Quality Control Check Report. Stage: After Finishing Stage III (Apartments)

MAYFLOWER PLATINUM

Details of Additions & Alterations

Flat No	107	Block no.	'A' ✓
Flat Area	1800 sft	Type	Deluxe / Luxury
Buyer Name	Ballary Madhavi Latha		
Phone No.	9491144194(c)/9482519879	Email	ballary1963@gmail.com

PLUMBING PLAN OF A7

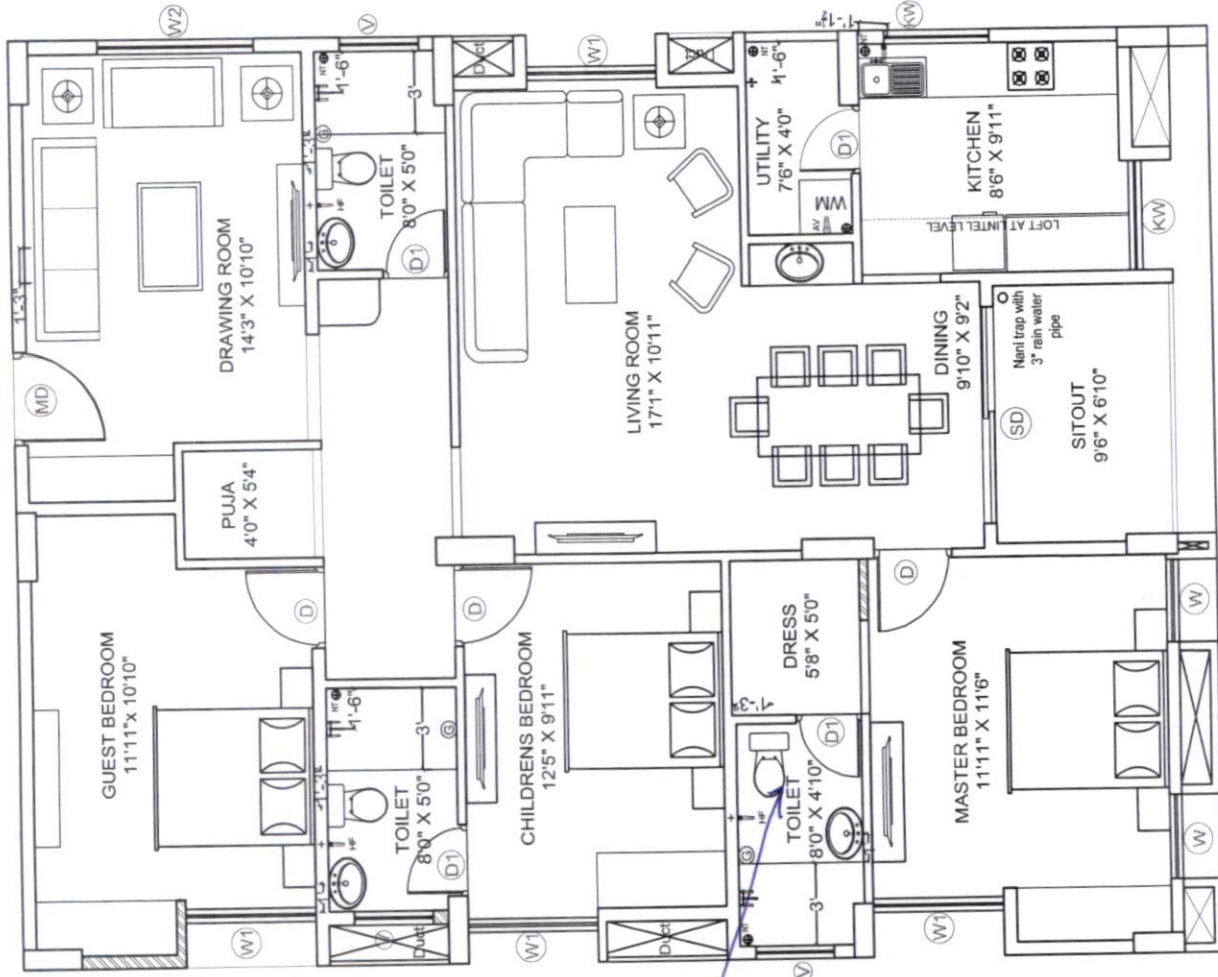
- ① Same as model flat
- ② EWC in MBR to be shifted from west facing to south facing.

To be shifted to south facing.

Sr. NO	Description of A&A request by customer	Addition & alterations permitted as per guidelines	approved by site engg	MDS approval required	At extra cost	Modified plans from HO required
1	EWC in Master to be shifted from west facing to south facing	yes	yes	yes	N	N
2	Puja wall to be extended by 2'6" towards north side	yes	yes	yes	Y	Y
3						
4						
Remarks By MD

ELECTRICAL PLAN OF FLAT-A7

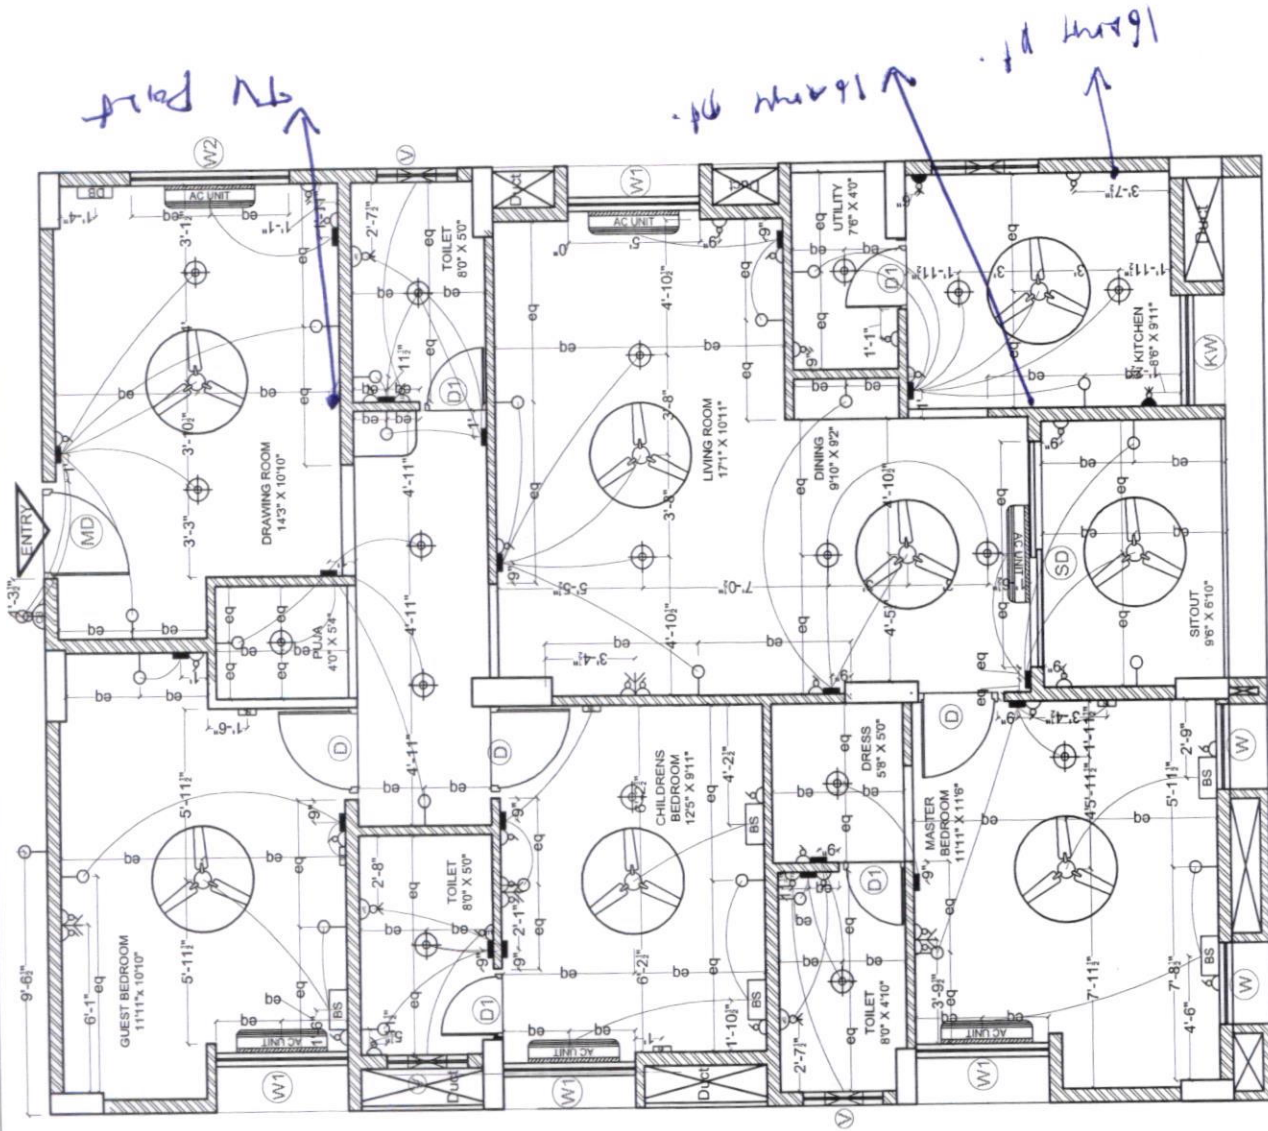
- ① 16 amp 24 Kitchen - 220P. (marked on plan.)
- ② TV point on drawing area (marked on plan)

Other Changes: ① Puja wall to be extended by
2'6" towards north side (marked
on plan)
